**PLEASANT PRAIRIE PLAN COMMISSION MEETING
VILLAGE HALL AUDITORIUM
9915 39th AVENUE
PLEASANT PRAIRIE, WISCONSIN
6:00 P.M.
MARCH 23, 2015**

- A. **PUBLIC HEARING AND CONSIDERATION OF PLAN COMMISSION RESOLUTION #15-06 FOR THE FOLLOWING COMPREHENSIVE PLAN AMENDMENTS** for the request of Leah Berlin on behalf of Kwik Trip, Inc. related to the proposed development of a Kwik Trip to be located at the southwest corner of STH 50 and CTH H: 1) to amend the Village 2035 Land Use Plan Map 9.9 to remove the urban reserve land use designation from the property identified as Tax Parcel Number 91-4-122-081-0010 to ensure that both the Zoning Map and the Comprehensive Land Use Plan are consistent; and 2) to update Appendix 10-3 of the Village of Pleasant Prairie Wisconsin, 2035 Comprehensive Plan to reflect the above noted changes to the 2035 Land Use Plan Map 9.9.

- D. **PUBLIC HEARING AND CONSIDERATION OF A CONDITIONAL USE PERMIT INCLUDING SITE AND OPERATION PLANS AND DIGITAL SECURITY IMAGING SYSTEM AGREEMENT AND ACCESS EASEMENT** for the request of Leah Berlin on behalf of Kwik Trip, Inc. related to the proposed development of a Kwik Trip to be located at the southwest corner of STH 50 and CT

DRAWN BY: JSK/RWI
SCALE: 1" = 30'
JSD PROJ. NO.: 14-6612A
DATE: 02-15-2015
SHEET: 7 OF 22 SP4.1

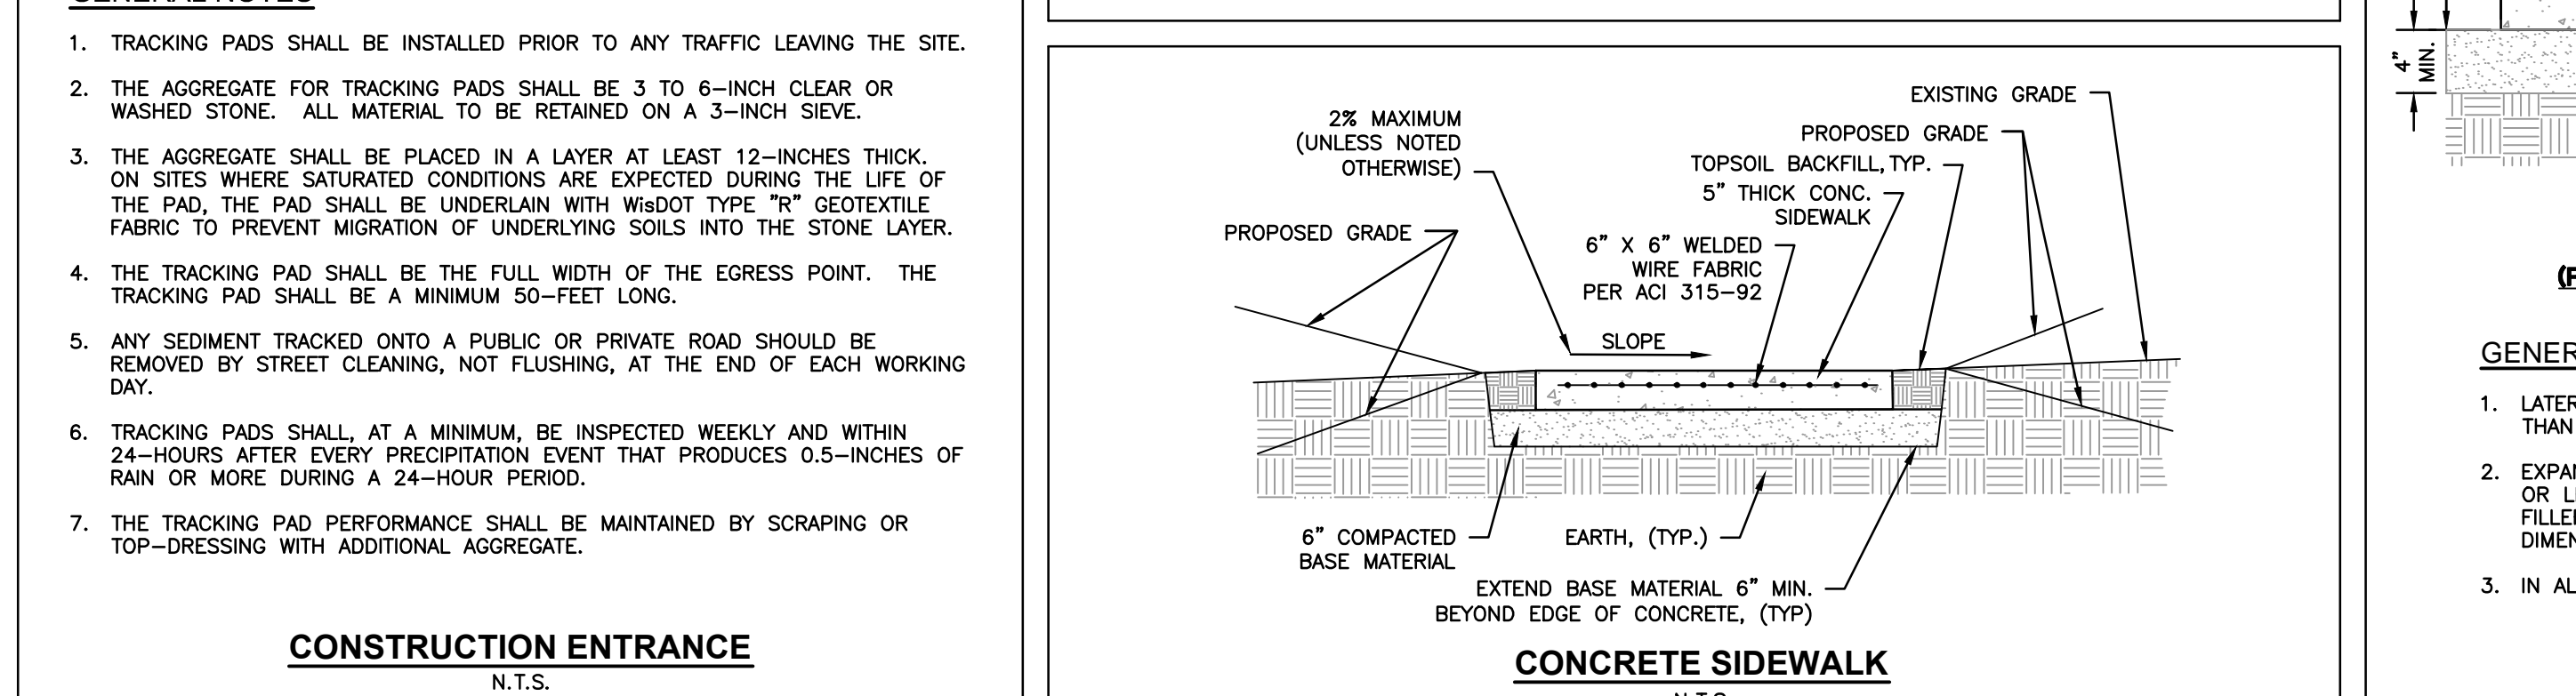
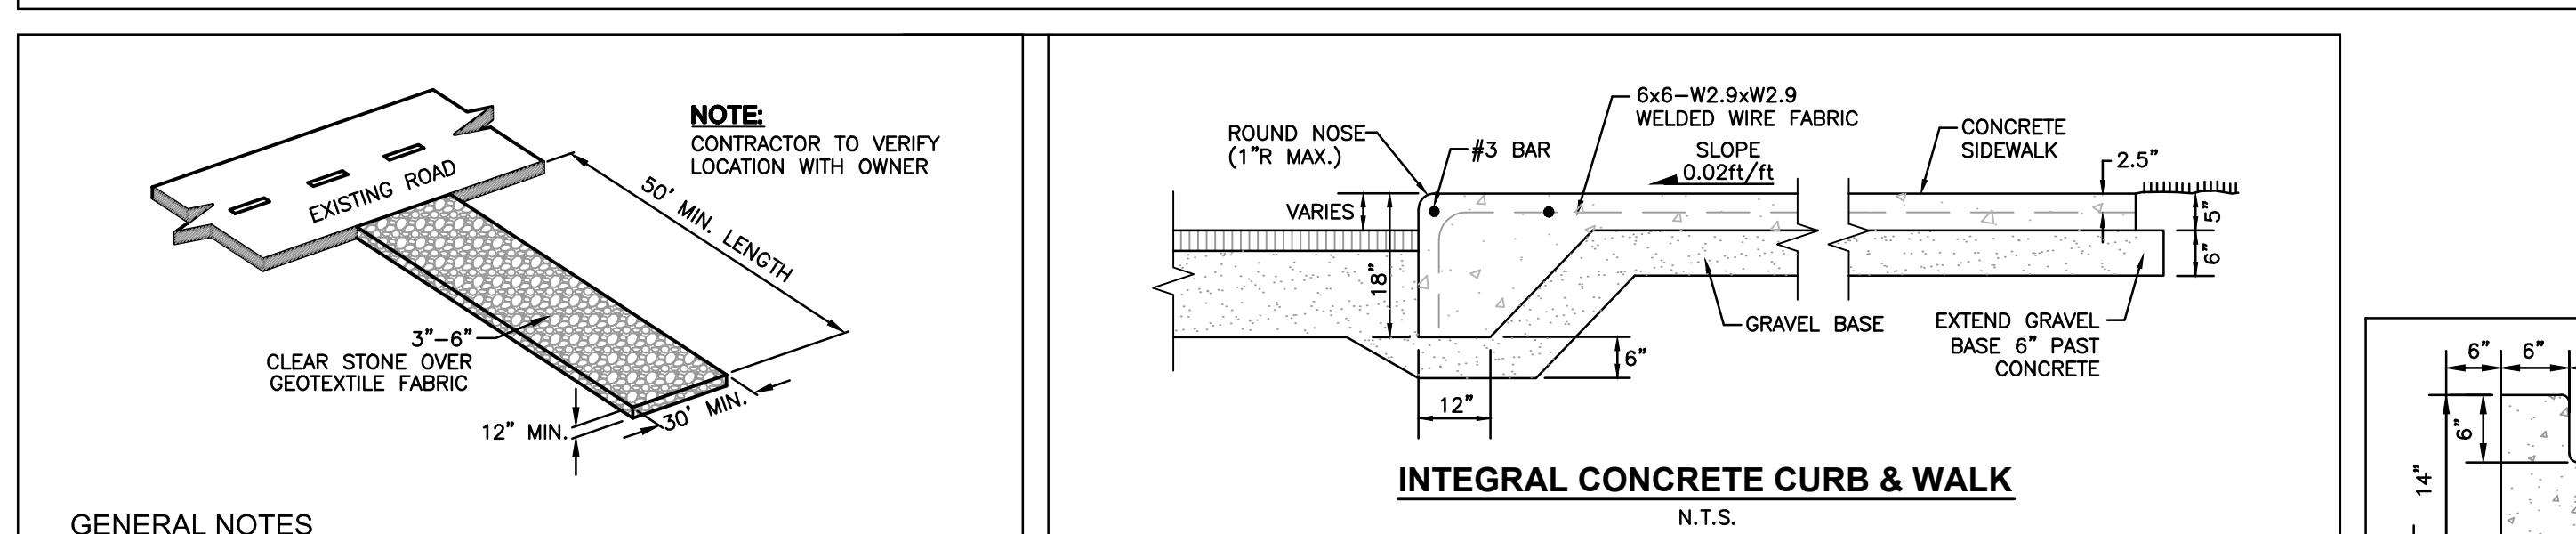
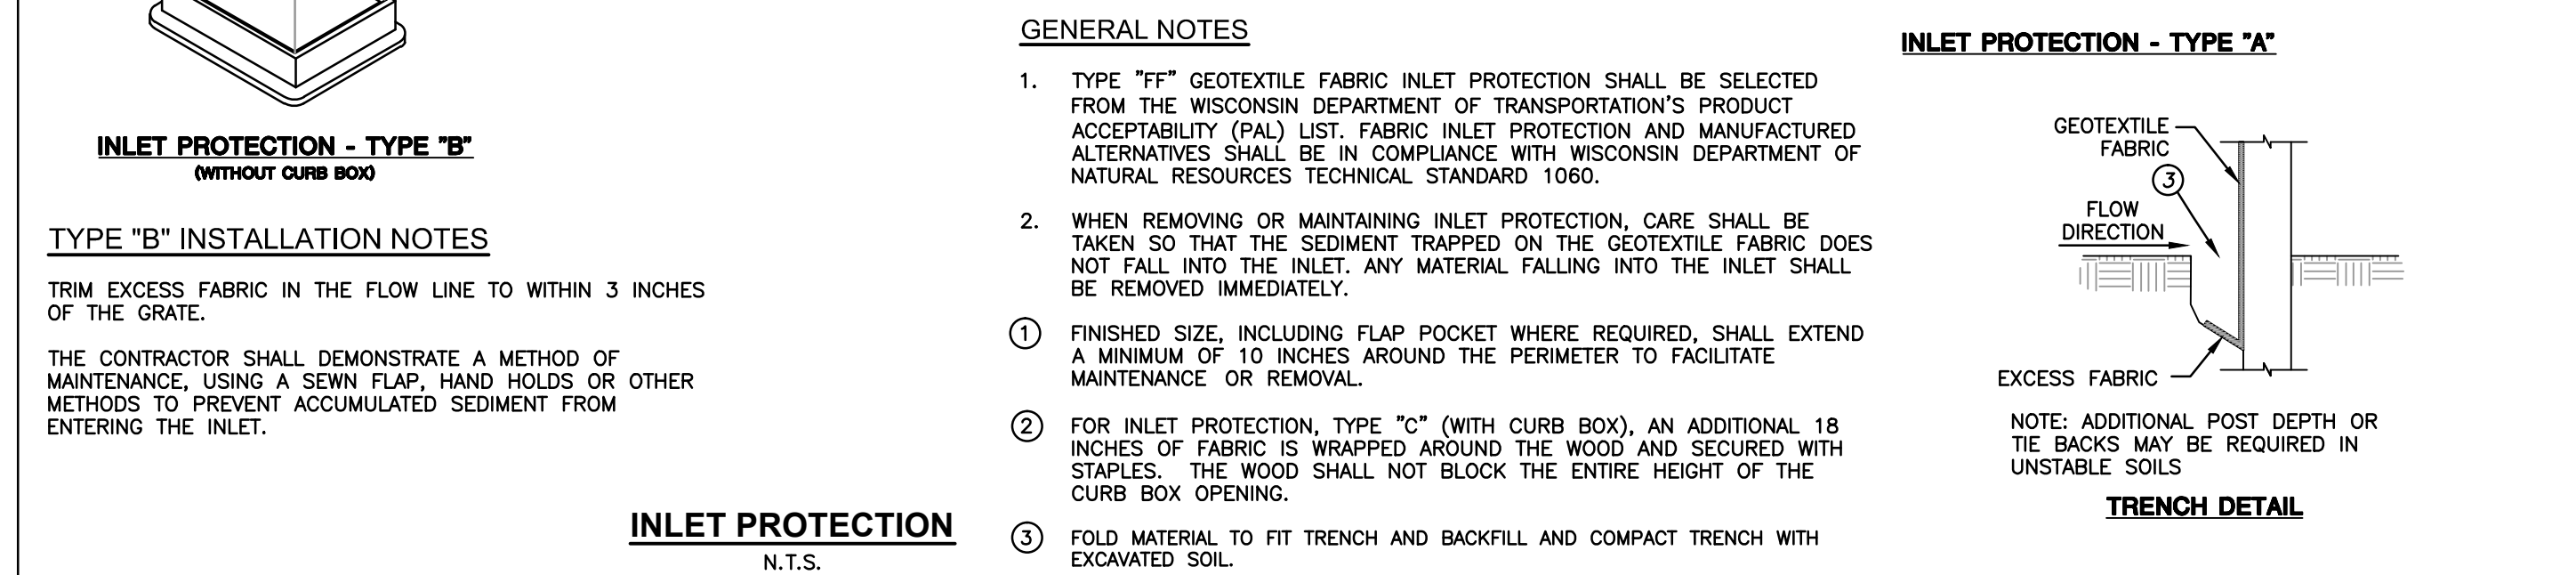
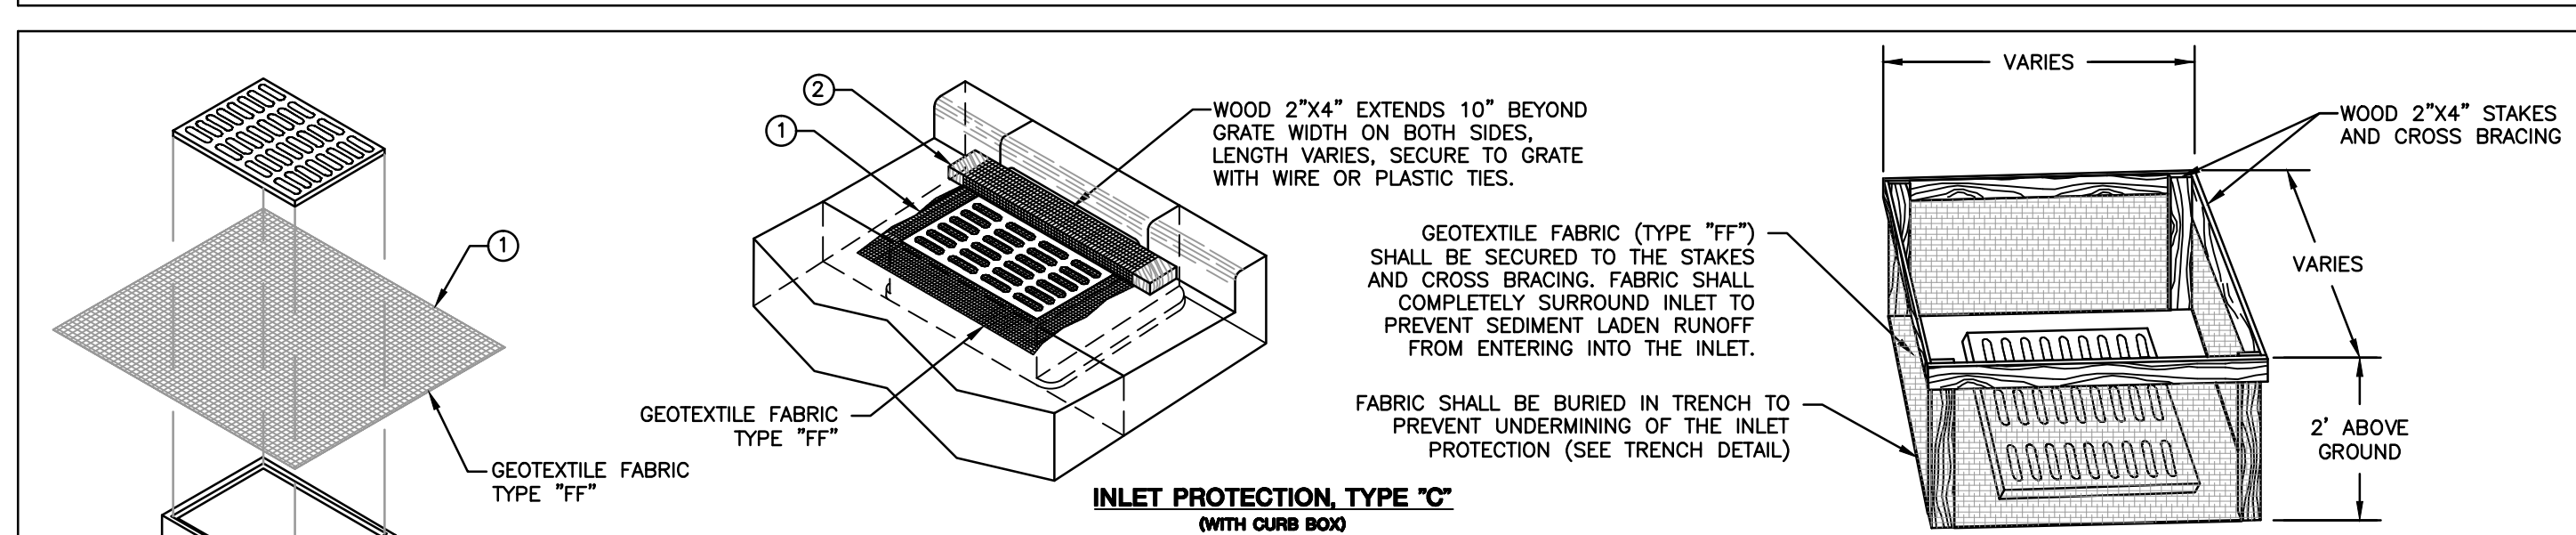
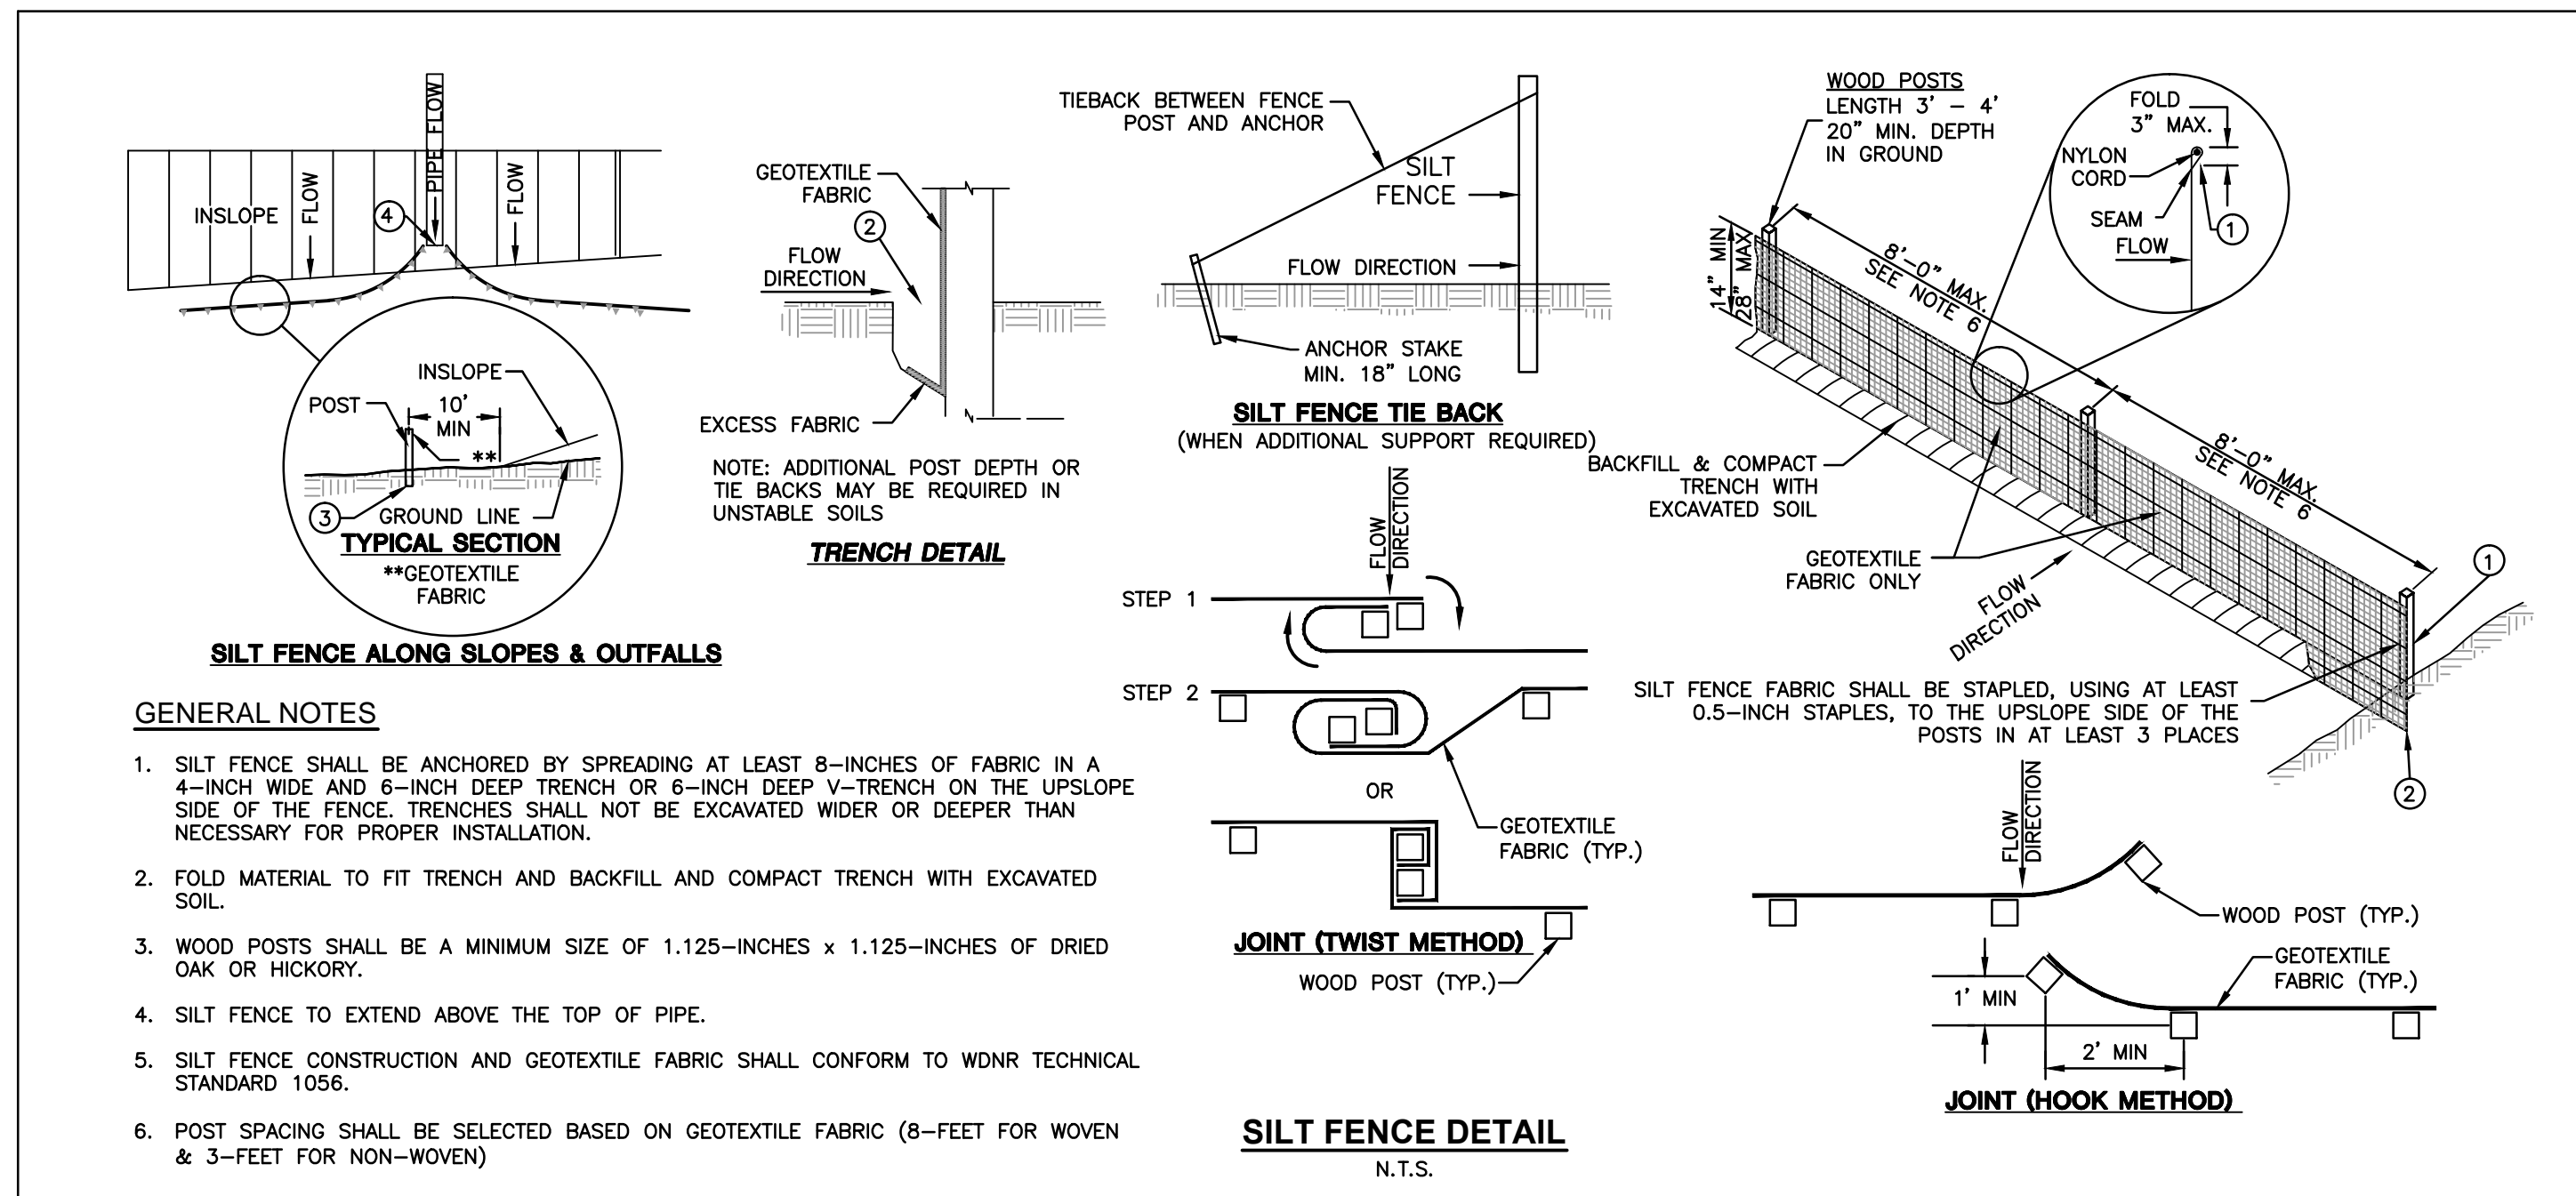
- (b.) Change the contact information for Utility Note #15 to the Village Public Works Department, 262-925-6700.
- viii. On the *Utility Plan – Sanitary Sewer and Water Services (Sheet SP4.1)* the following shall be changed:

- (a.) Copy over applicable notes for sewer and water construction located on sheet SP4.0.
 - (b.) Provide elevations at all water service changes in grade, bends and tees.

5. All bends in the sanitary service shall be in manholes. Additional manholes will need to be added, revise layout of onsite sanitary.
